SUBJECT: Submits proposed mod to amend requests Revs A & B re overall conversion of current TS to improved TS based upon NUREG-1434, rev 1.

Subject: **WNP-2, OPERATING LICENSE NPF-21
REQUEST FOR AMENDMENT TO TECHNICAL SPECIFICATIONS**

REQUEST FOR AMENDMENT TO THE TECHNICAL SPECIFICATIONS

^⑰
 Insert Figures 3.4.11-1, 3.4.11-2, and 3.4.11-3

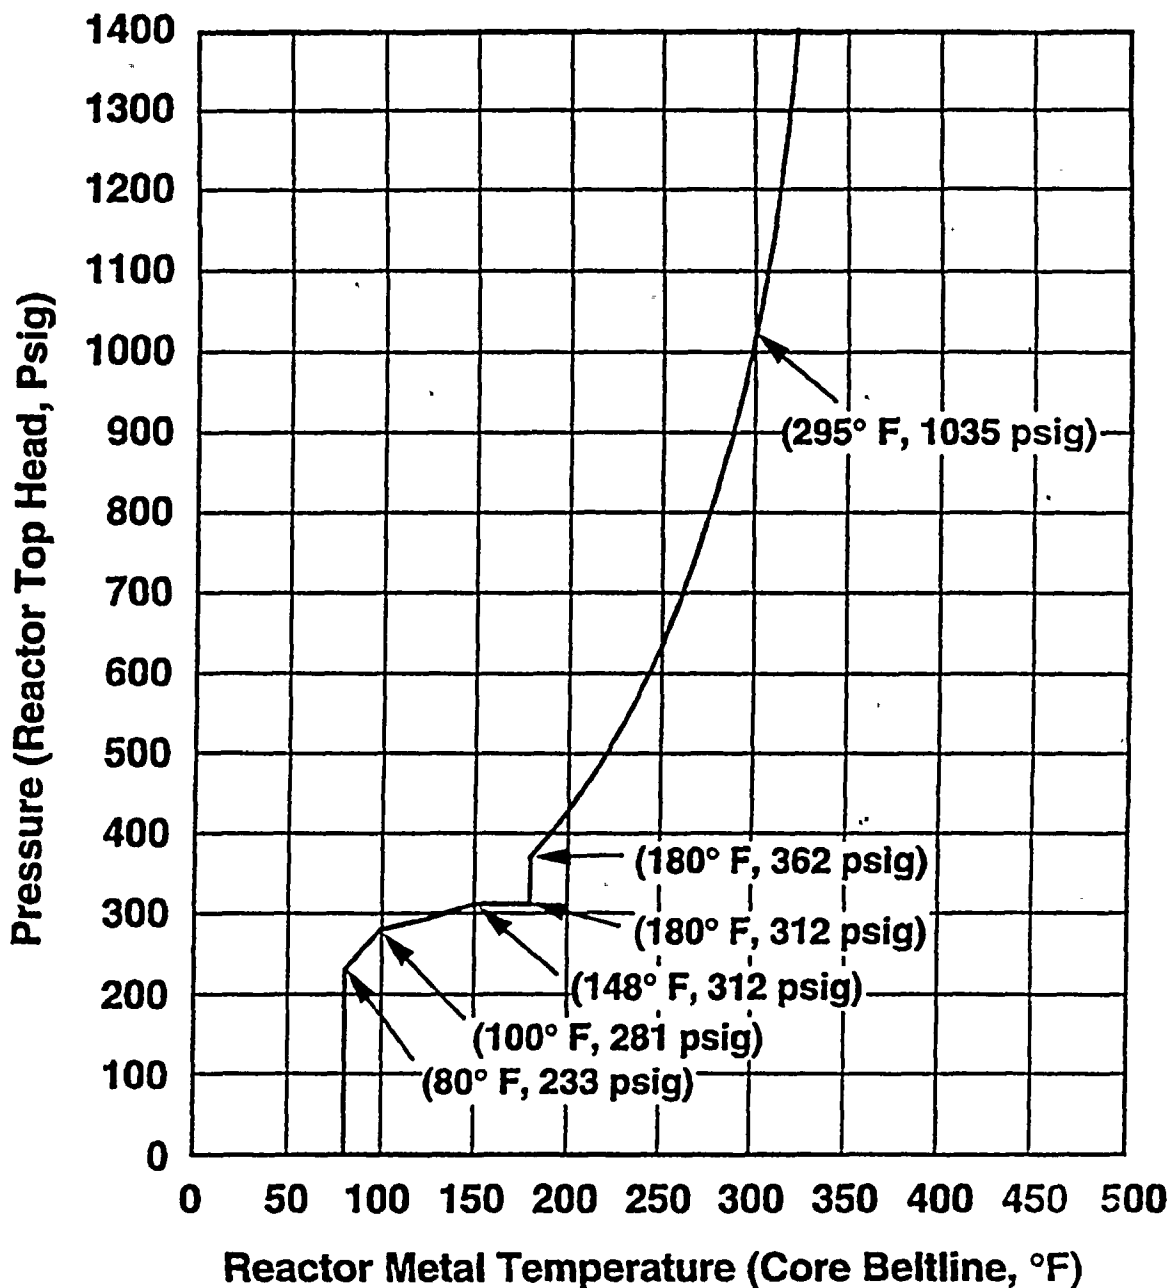
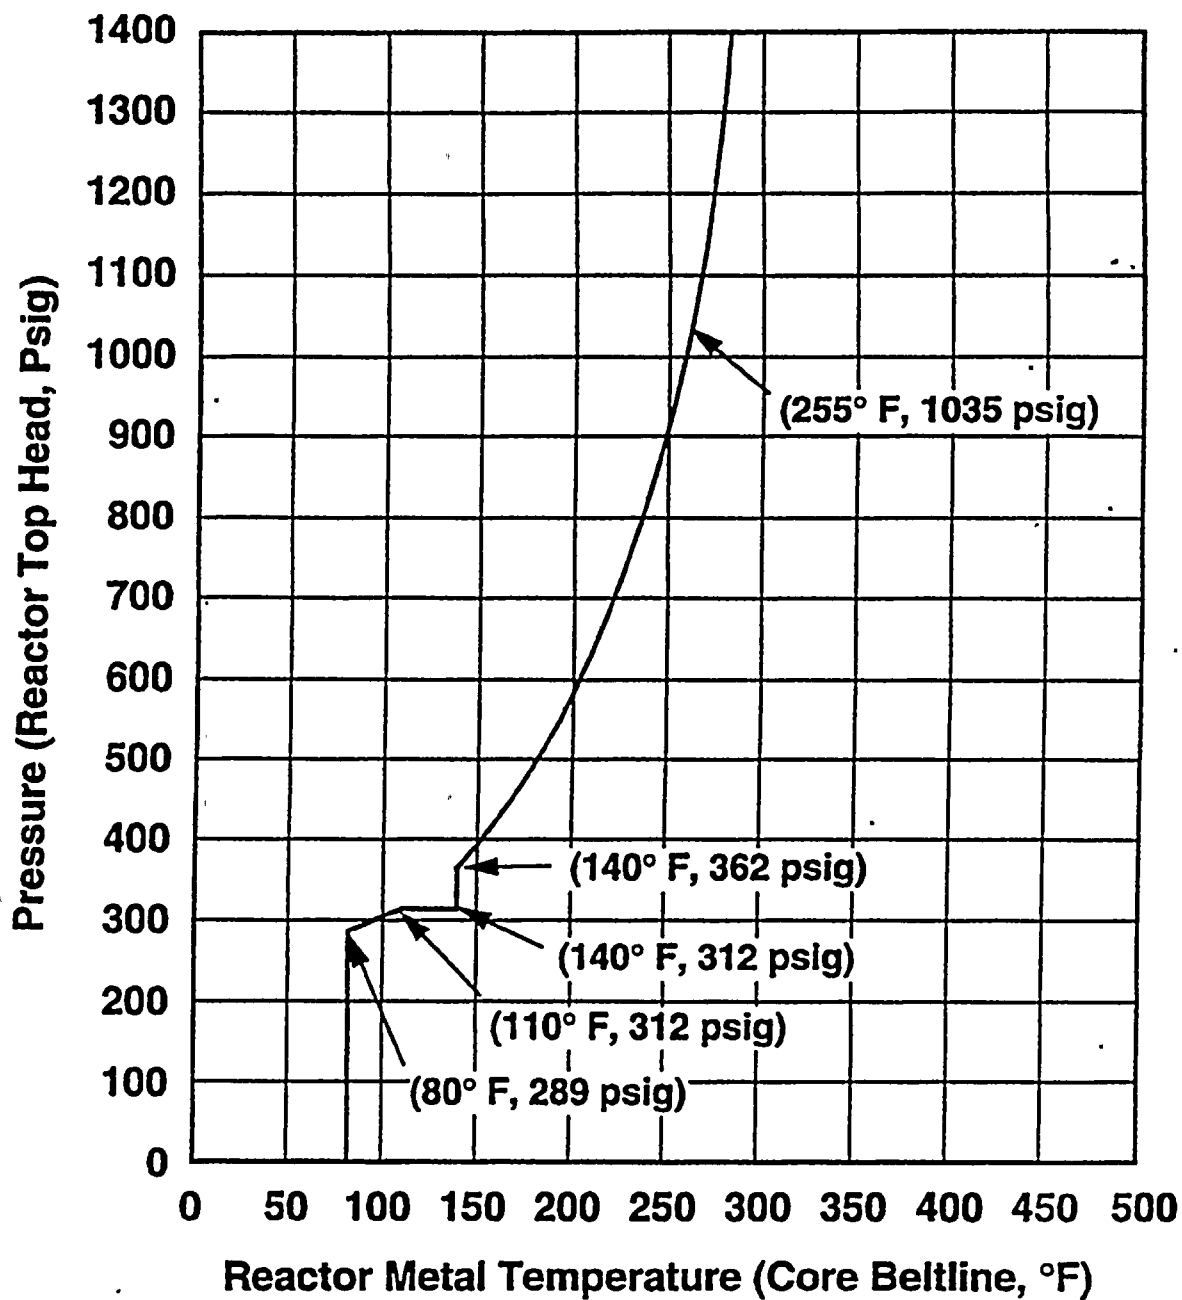
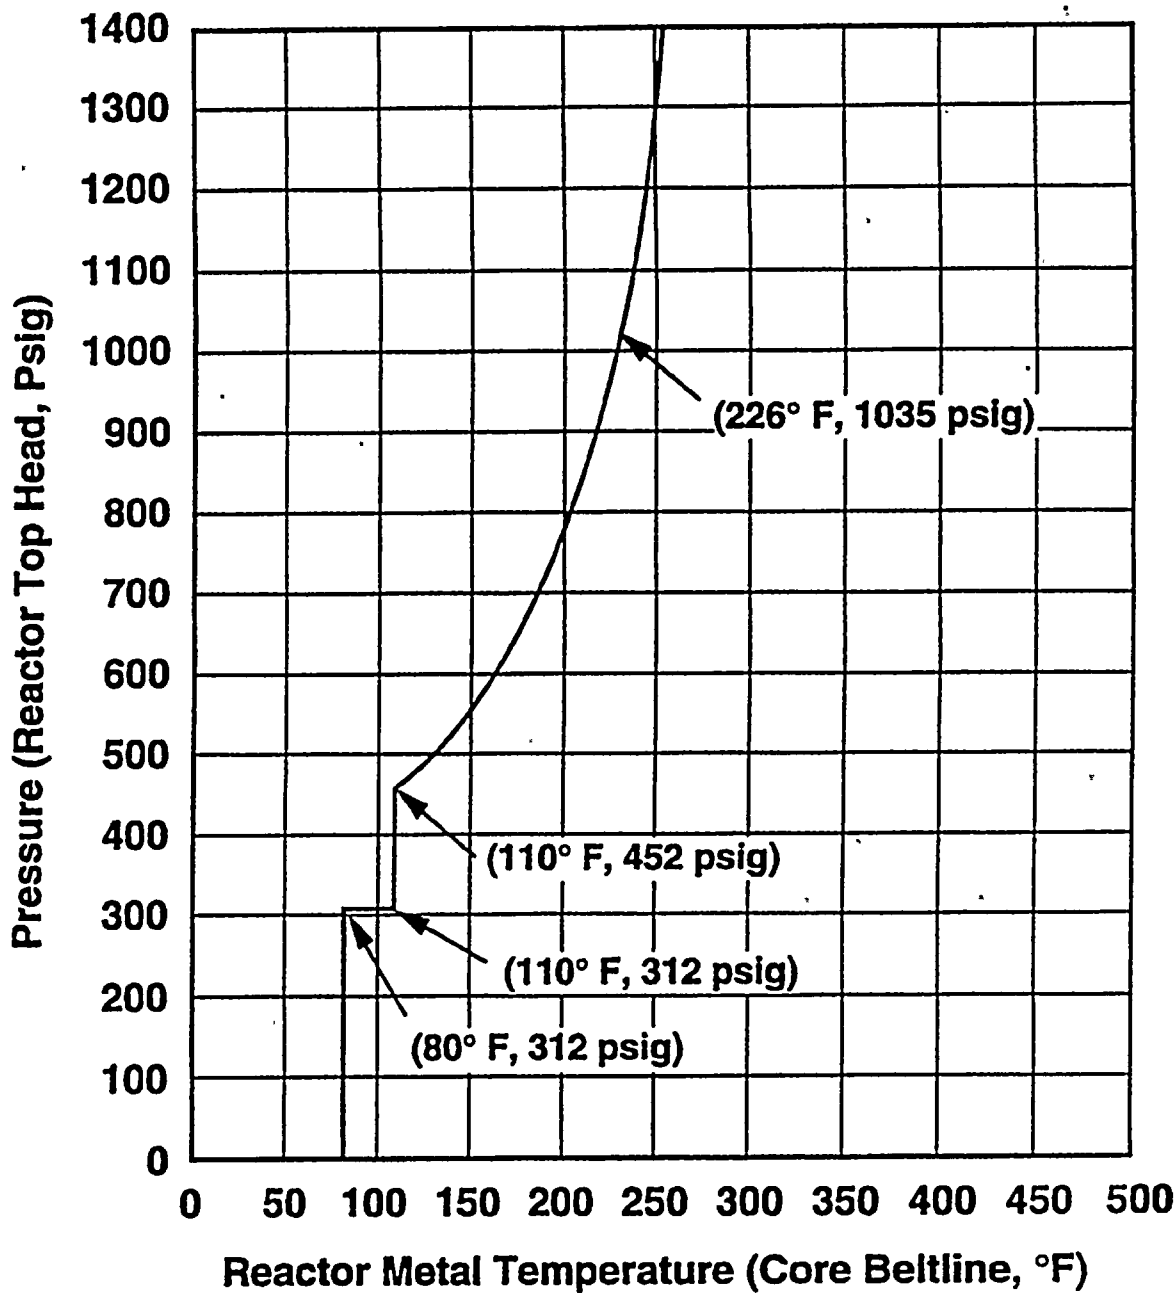
The PTLR has been deleted and the actual limits (consistent with the CTS limits) have been added into the ITS.

(17) { Verify ^{a.} RCS pressure ^{out} and RCS temperature, and RCS heatup and cooldown rates are within the limits specified in the P.T.R. ^{applicable} <u>Figures 3.4.11-1, 3.4.11-2, and 3.4.11-3</u> | 30 minutes |

| SR 3.4.11.2 Verify RCS pressure and RCS temperature are within the criticality limits specified in the P.T.R. ⁽¹⁷⁾ <u>Figure 3.4.11-3</u> | Once within 15 minutes prior to control rod withdrawal for the purpose of achieving criticality. |

Figure 3.4.11-3 (Page 1 of 1)
Nuclear Heating and Cooldown Curve

Figure 3.4.11-2 (Page 1 of 1)
Non-Nuclear Heating and Cooldown Curve

Figure 3.4.11-1 (Page 1 of 1)
Inservice Leak and Hydrostatic Testing Curve
